NUFSD BOND PROJECT PHASE 5 - HIGHVIEW

No.	Description	Date
1	BID ADDENDUM #4	02/05/25

SHEET NAME:
HVAC ROOF PLAN

HE-M106

A17 HVAC ROOF PLAN

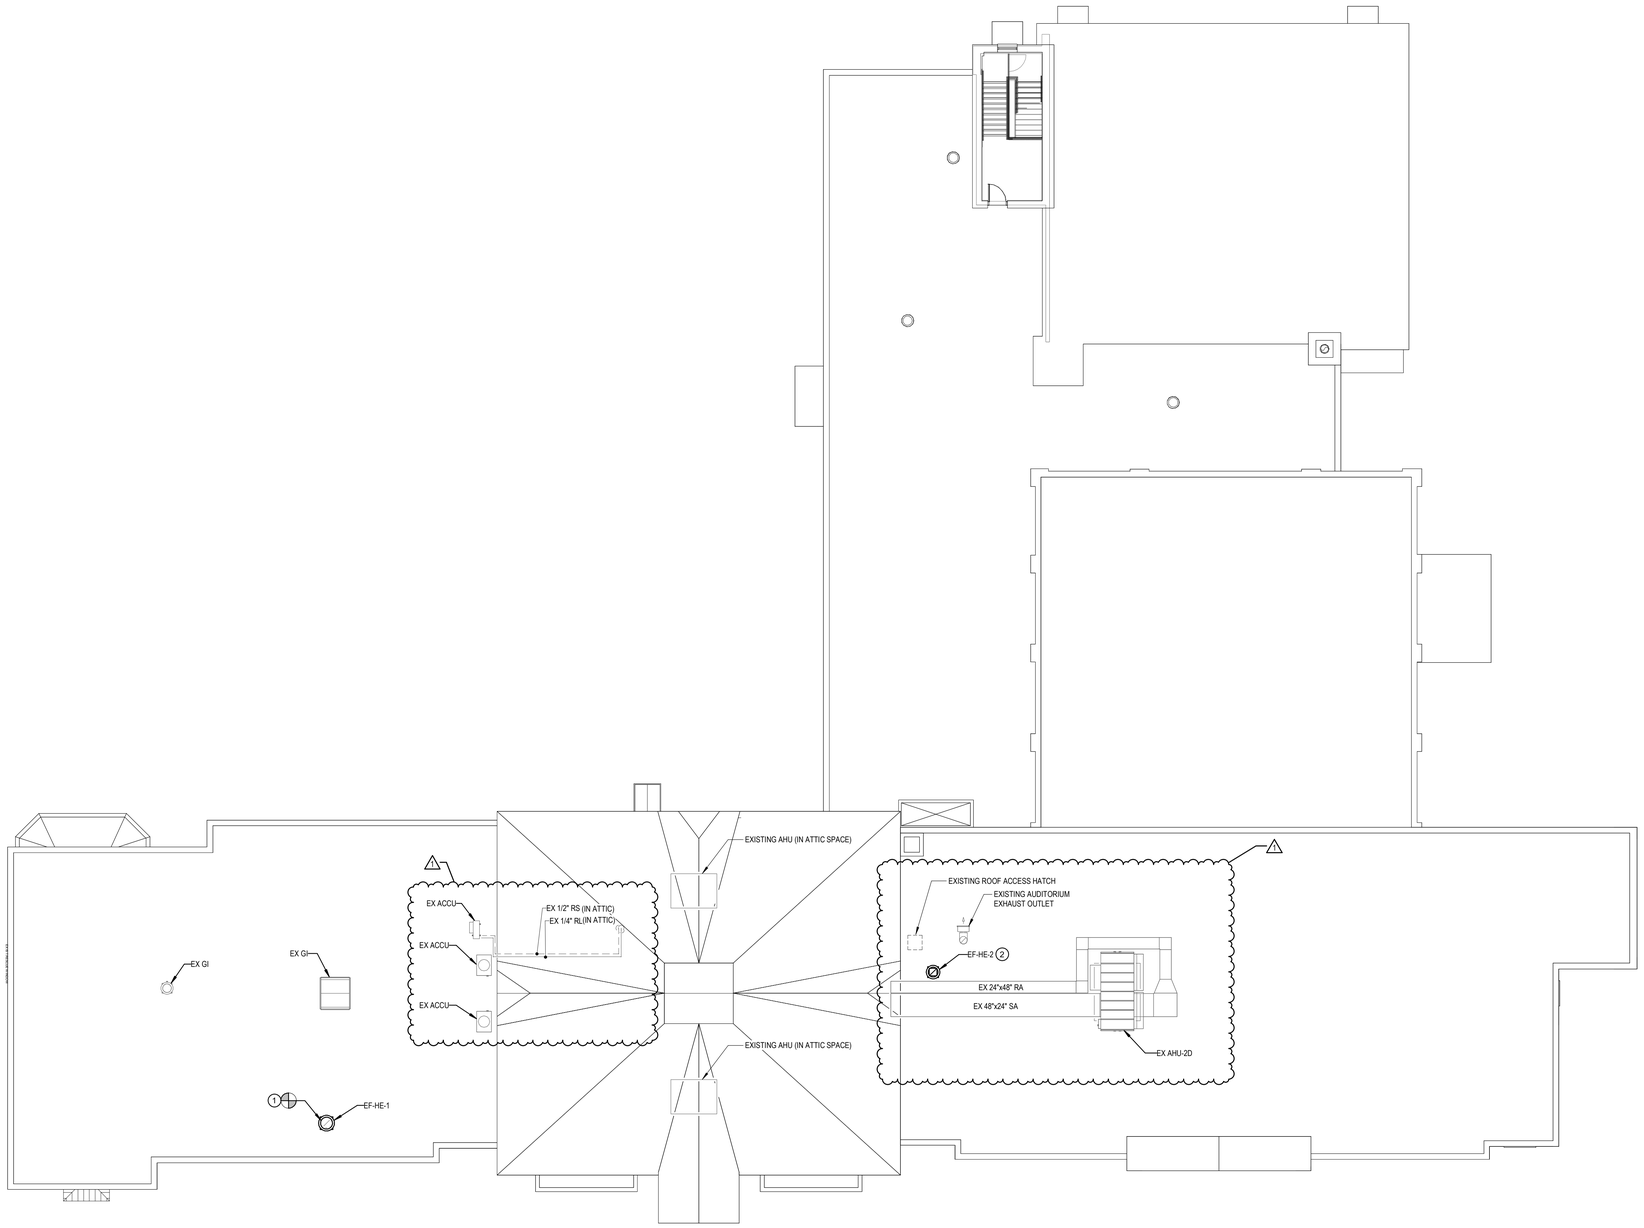
1. PROVIDE EXHAUST FAN AND ROOF CURB ADAPTER AT LOCATION OF REMOVED EXHAUST FAN AS SHOWN. USE THE EXISTING DUCT PENETRATION THROUGH ROOF. EXTEND EXISTING EXHAUST AIR DUCT RISER UP TO ROOF FAN DUCT CONNECTION AS REQUIRED FROM TEMPORARY CAP. PROVIDE MOTORIZED DAMPER WITHIN RISER UP TO FAN CONNECTION. PROVIDE ROOF CURB ADAPTER ON TOP OF EXISTING ROOF CURB.
2. PROVIDE NEW, ROOFTOP EXHAUST FAN WITH ASSOCIATED ROOF CURB, MOTORIZED DAMPER AND CONTROL WIRING AT LOCATION REMOVED 18" ROUND EA VERTICAL DUCT PENETRATION THROUGH ROOF.
